**MARION TOWNSHIP PLANNING COMMISSION
AGENDA**

- 1) Review PUD#01-20 Tamarack Place (Sunridge III) Preliminary Site Plan Review
- 2) Review TXT#03-20 Planned Unit Development Overlay District (move 13.04 to EDS, add amending)

The 93-acre project is the last and final phase of the Sunridge P.U.D. To be called "Tamarack Place" the 4-phase site condominium PUD consists of 145 units. A total of 46 acres will be preserved as open space in the form of wetlands, woodlands, walking paths, and drainage system. The applicant is requesting an amendment to the originally approved PUD. While this phase continues to have 145 units as originally approved the layout has changed due to the significant wetlands, drain and other natural features. **While the Township has always expected this project to come to a completion there continues to be significant concerns with the traffic that will be generated once complete and the impact it will have on Township roads.**

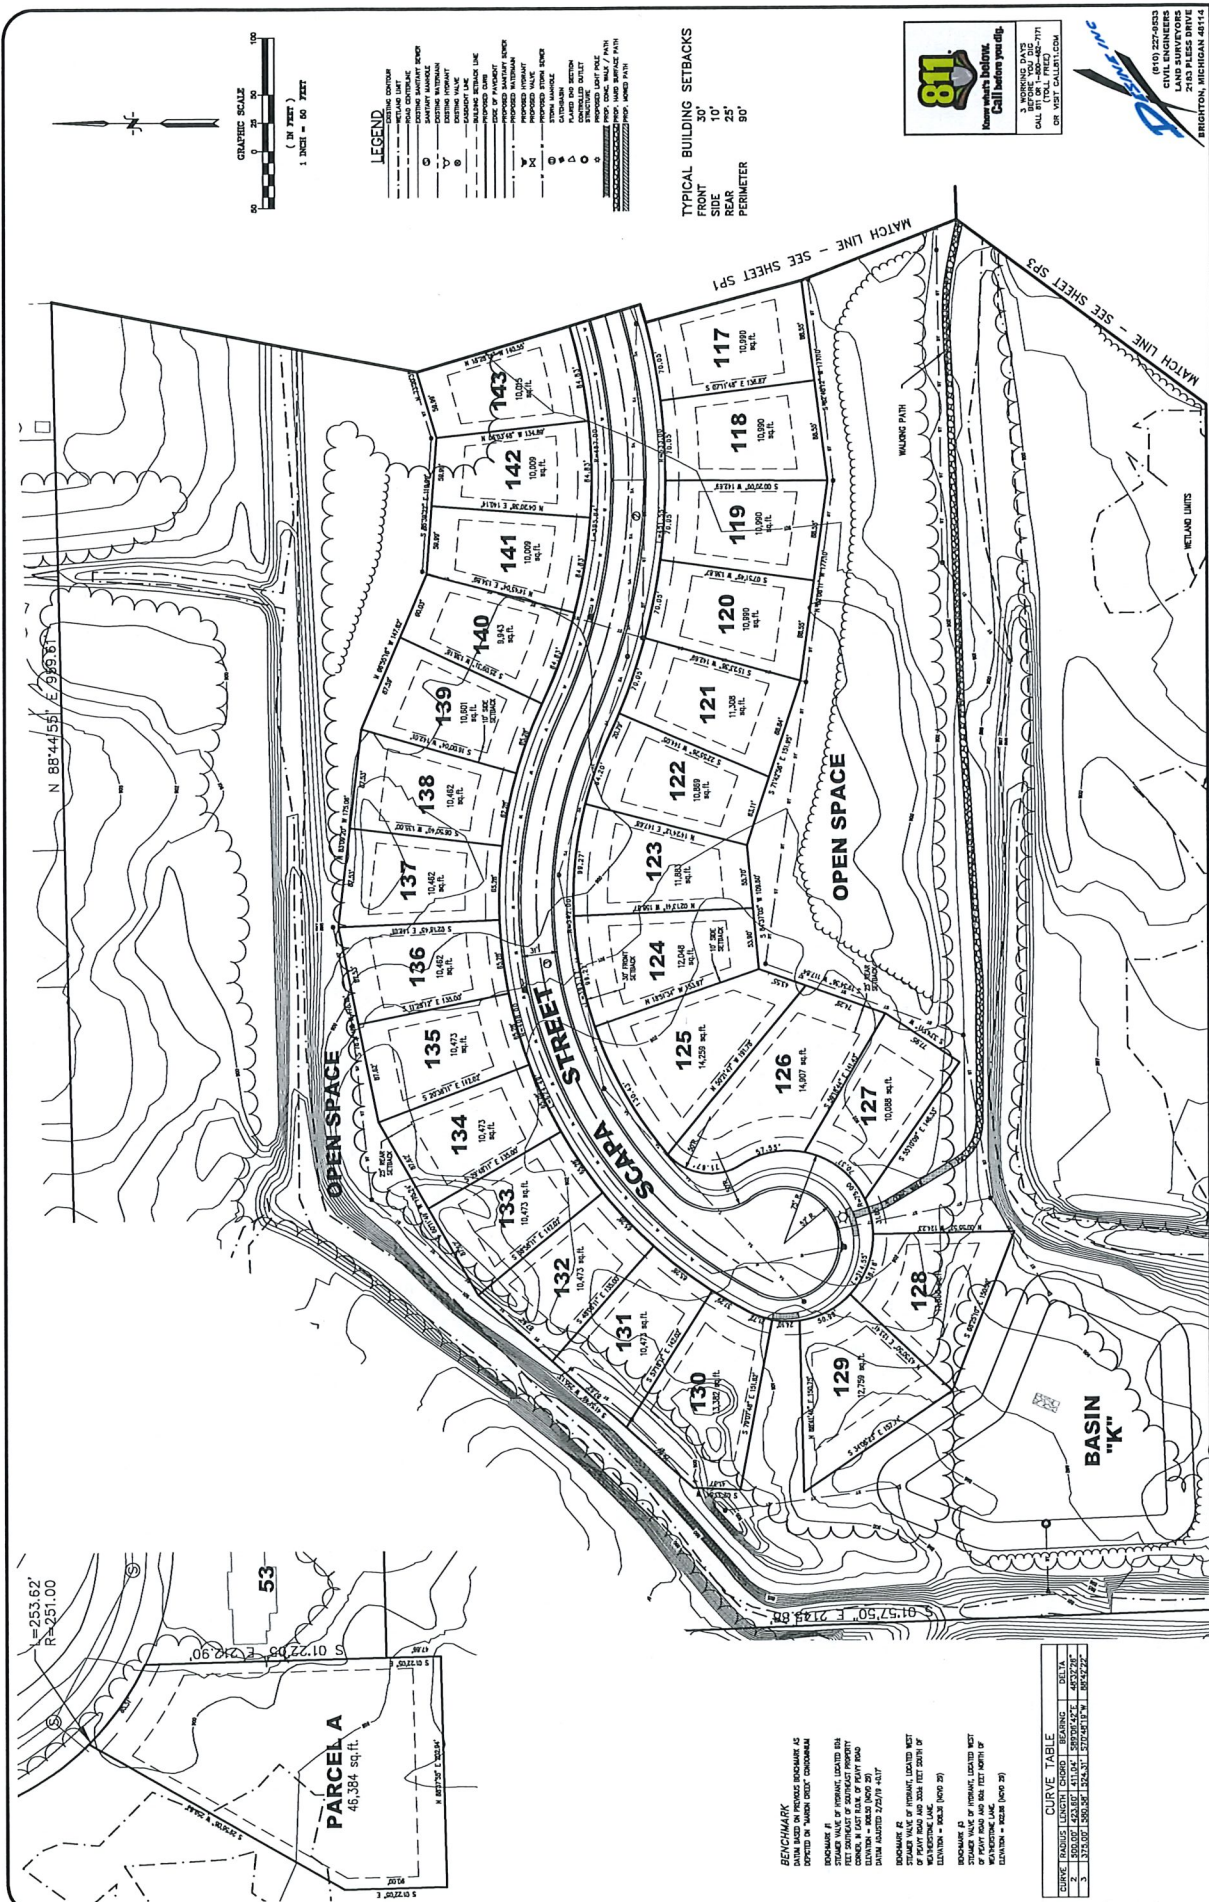
The proposed cul-de-sac radius at the outside edge of the pavement is 50 feet. The fillet radius from the proposed cul-de-sac to the tangent section is shown to be 50 feet on sheet SP3 on Edradour St, but the Curb Cul-De-Sac Detail shows a fillet radius of 75 feet. The Curb Cul-de-sac Detail should be updated so that it matches what is proposed in the Site Plan Sheet. The cul-de-sac on Linkwood Ct and Scapa St have more than 4 parcels fronting on the right of way for the cul-de-sac, which exceeds the maximum requirement.
